Newport Harbor High School Narrative Changes – Mechanical Addendum 1

January 26th, 2021

Attention: Mr. Lance Bidnick
Project: Newport Harbor High School
Newport Beach, California 92663
Subject: Narrative Changes – Mechanical Addendum 1

DOUBLE DUCT SUPPORT

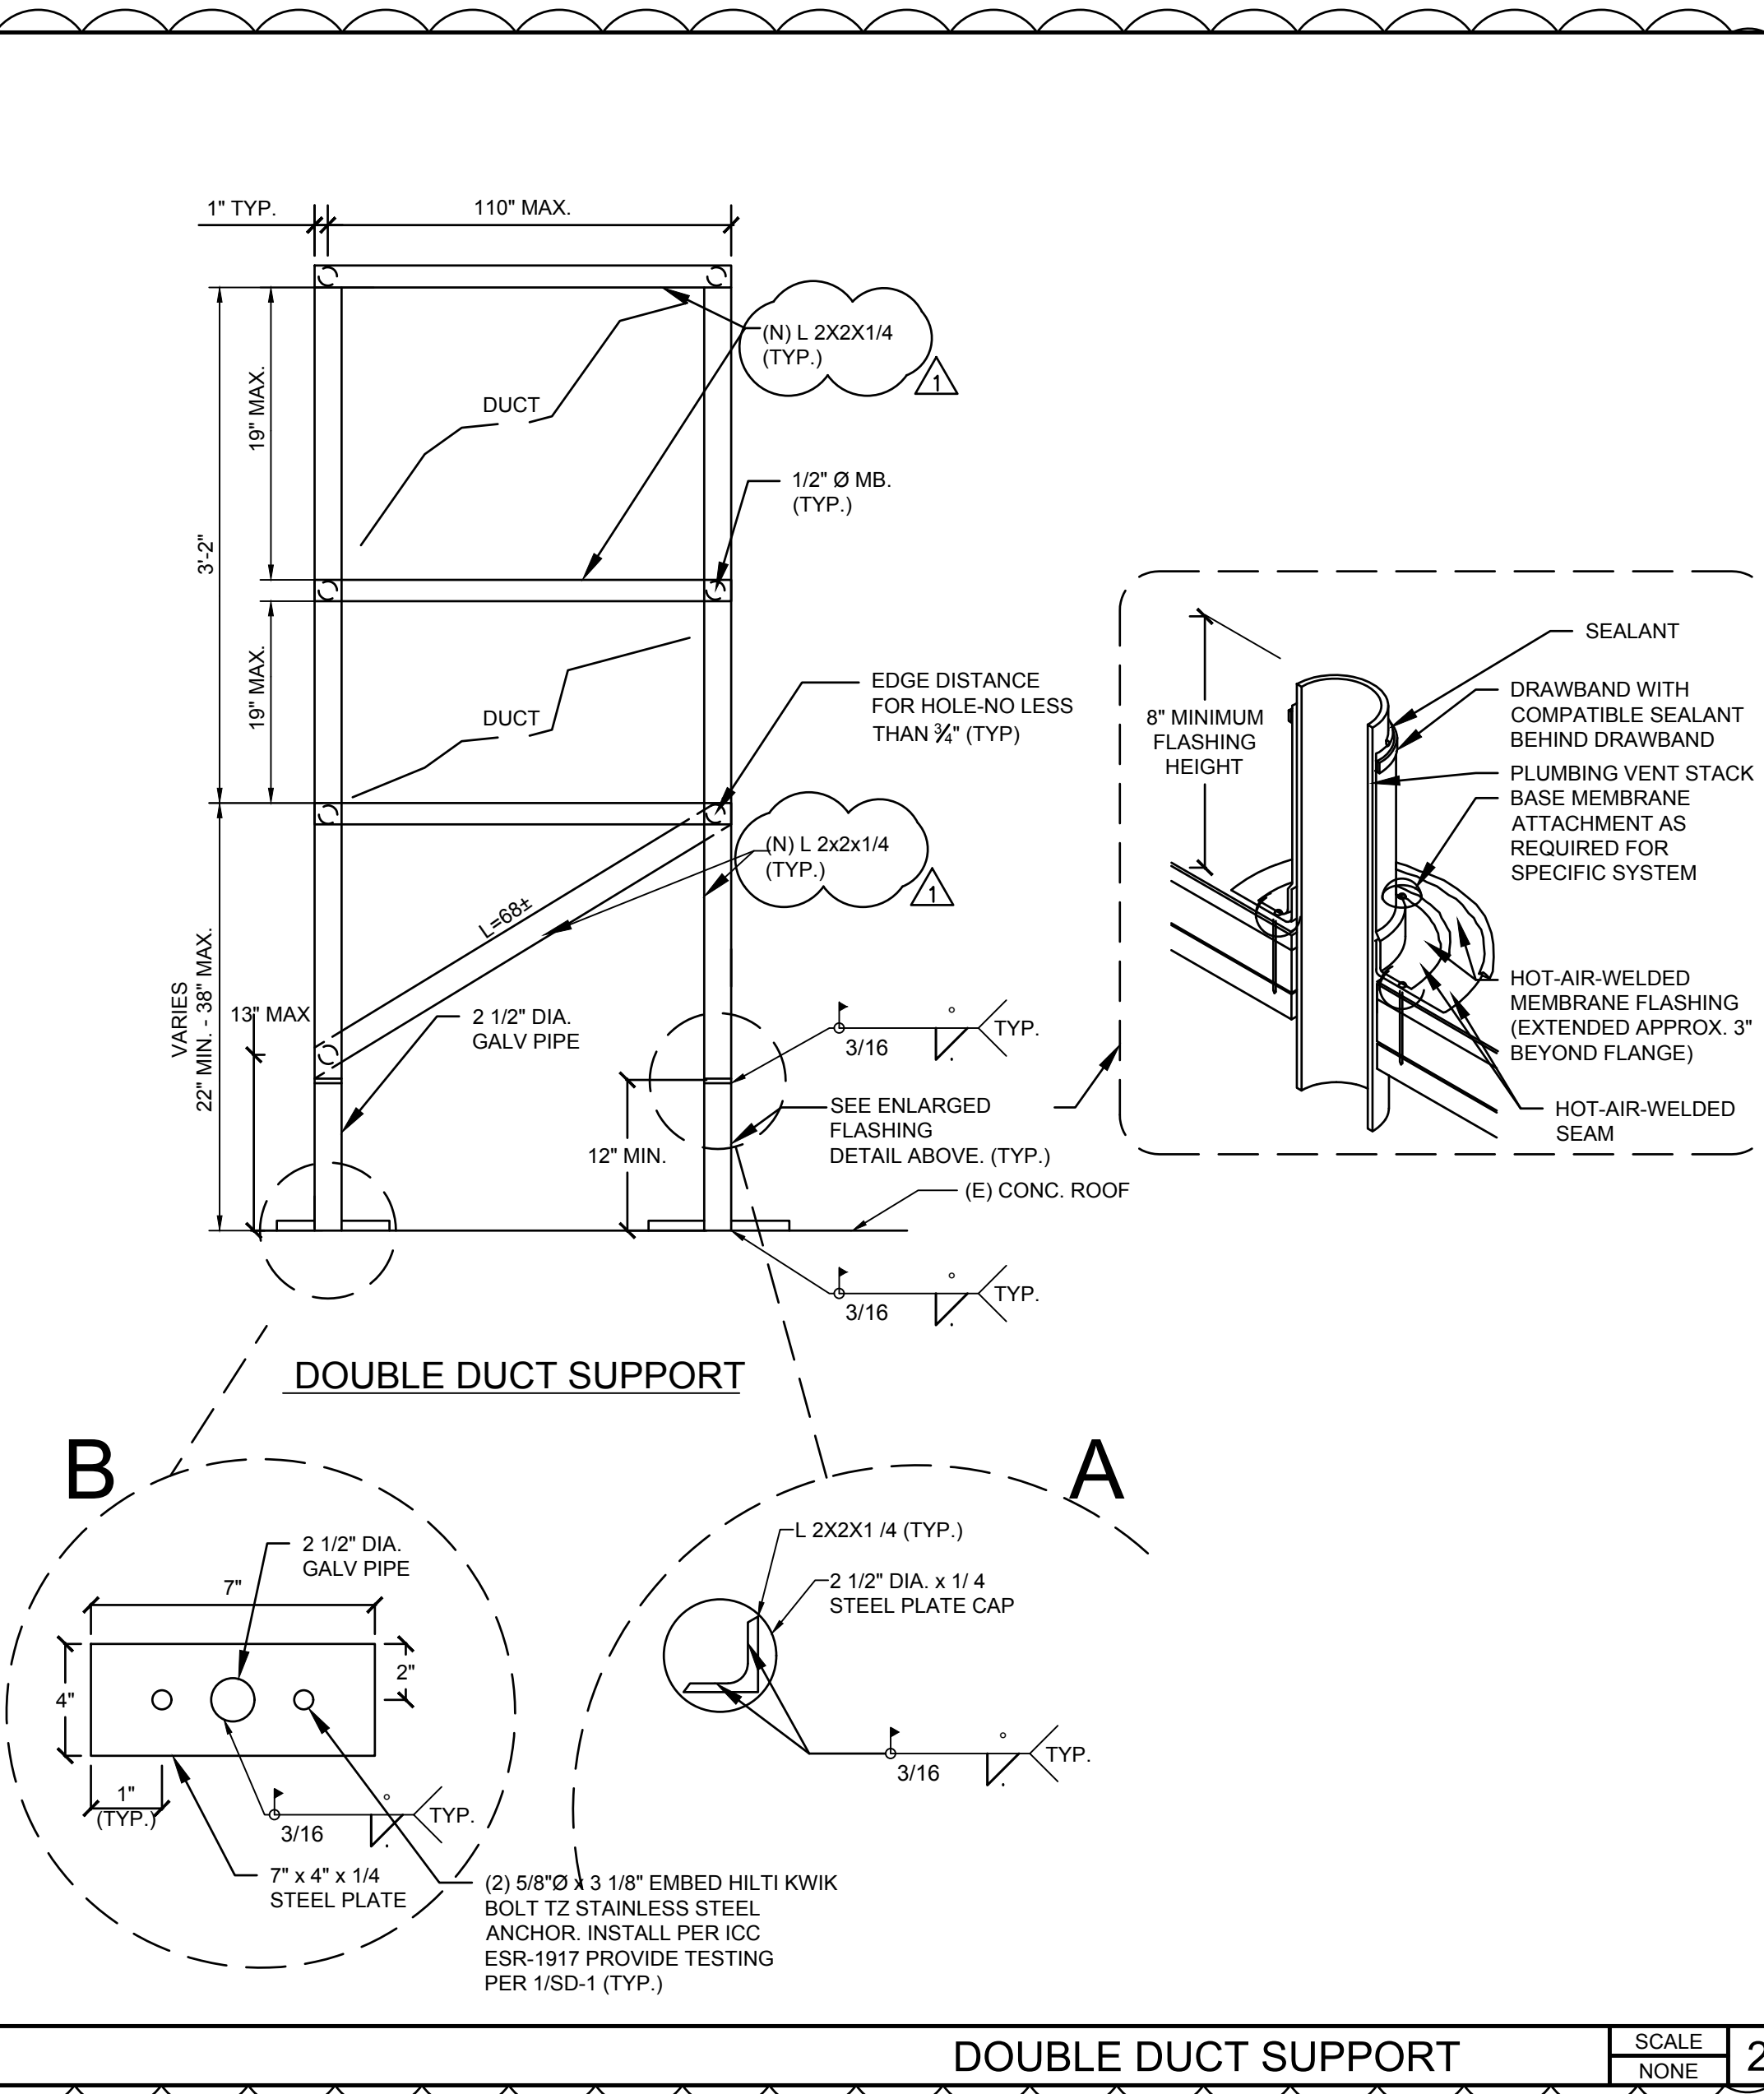
1. Revised detail 2 to identify duct supports as new (previously shown as existing). See delta 1 cloud
2. Revised detail 2 duct supports to round base and flashing. See delta 1 cloud.
3. Revised detail 2's enlarged views to reflect new assembly with round base.
4. Added enlarged isometric view for flashing pipe/boot in detail 2.
5. Revised detail 3 specifying Tractel TRM1200S for fall protection in place of Guardian CB-1. See revised sheet for changes.
6. Revised top view of fall protection detail #3. Size of base plate, and minimum edge distances to fit TRM1200S.
7. Added enlarged flashing detail for fall protection detail #3.

**EMBEDDED EDGE METAL DETAIL FOR PLATFORMS**SCALE
NONE**4**

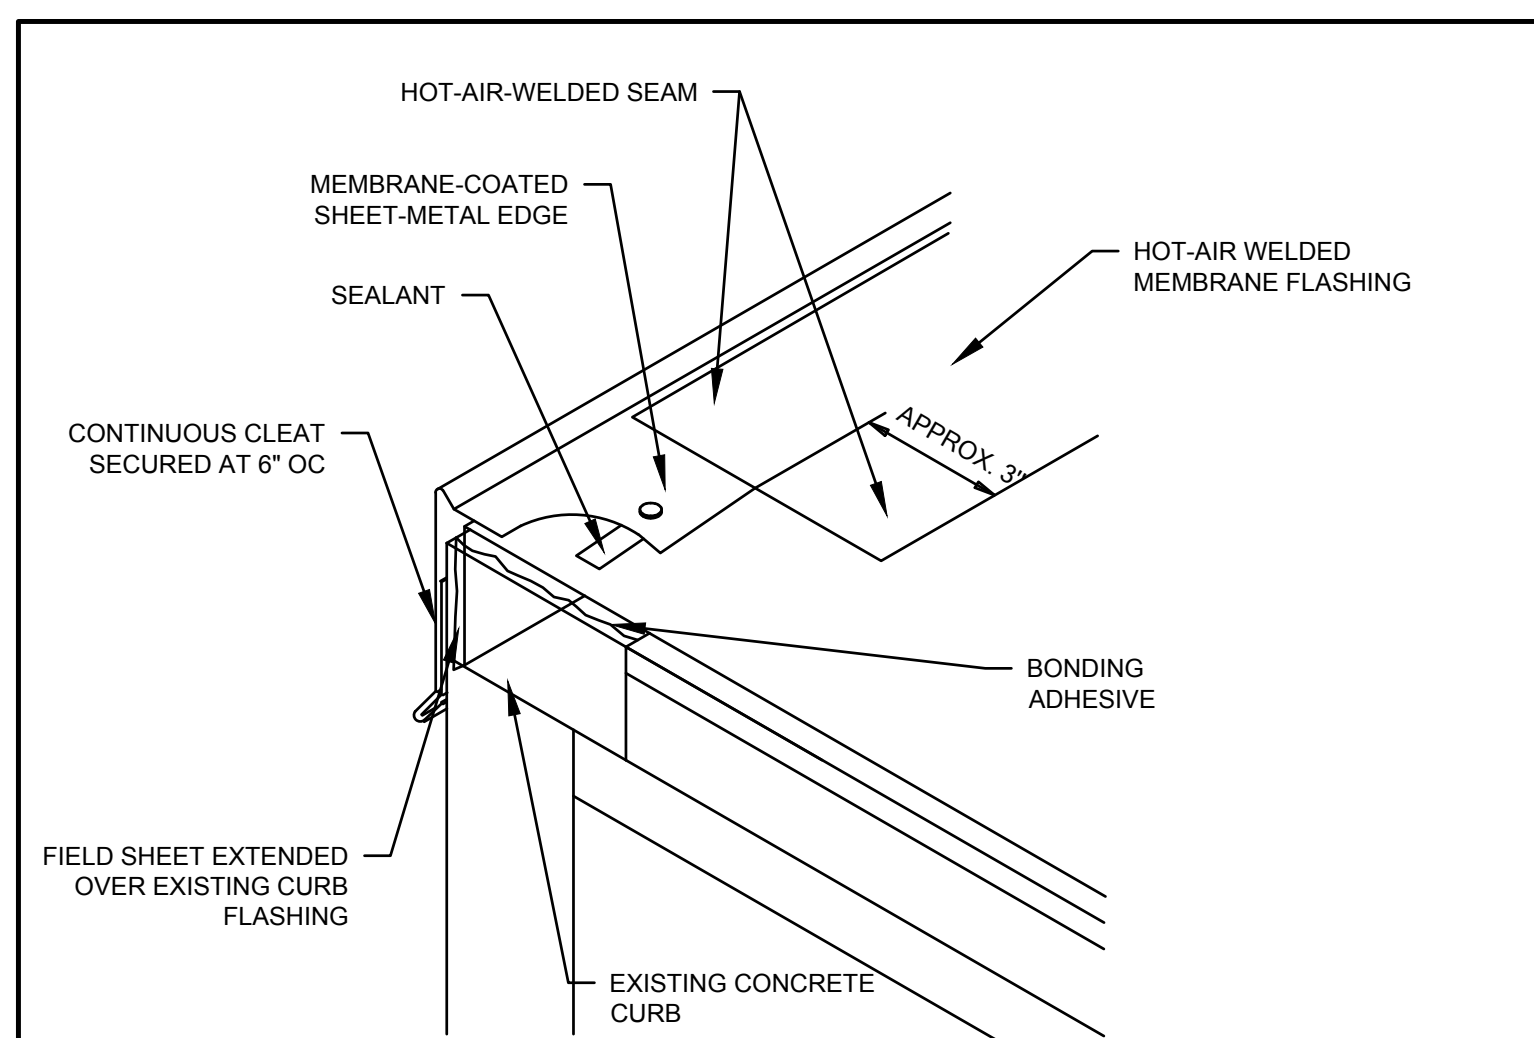
4. Revised construction keynote #14 specifying TRM1200S as an alternative for fall protection.
5. Added construction keynote #16 to repair and finish platform for duct supports and drops see detail #4/M-2.3 provided.

PIPING THRU CONCRETE ROOFSCALE
NONE**1****DETAIL-1**

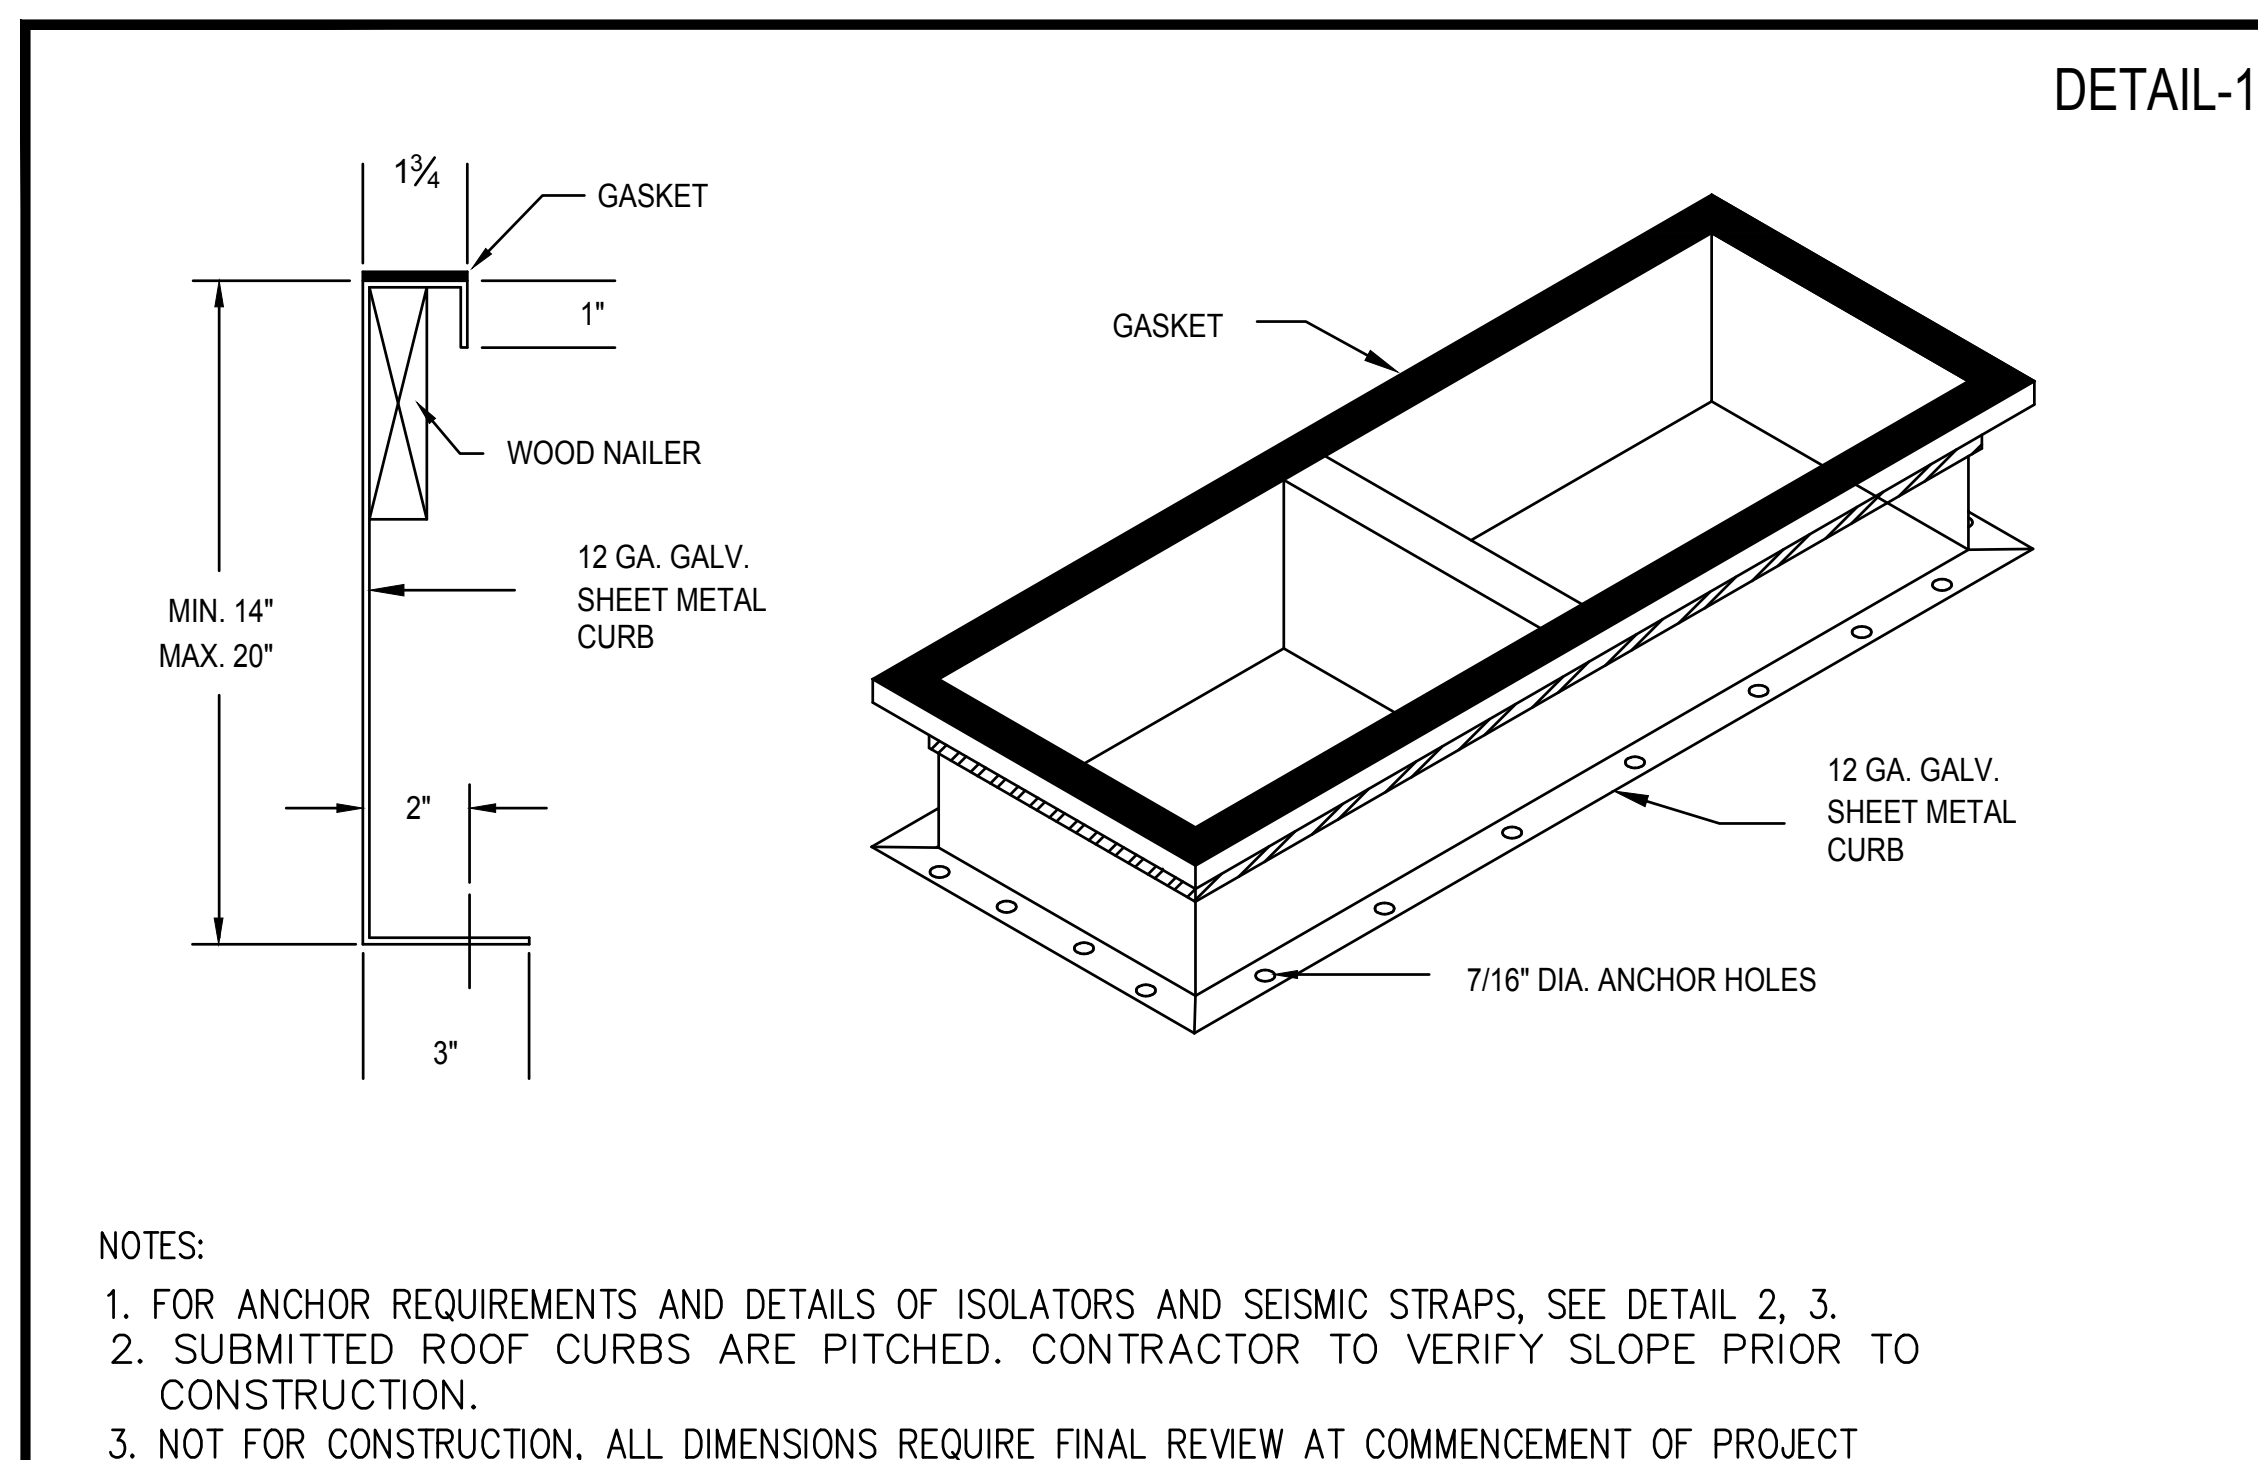
1. Added sheet with details; #1 for piping through roof leading from electrical/conduit boxes to be re-used
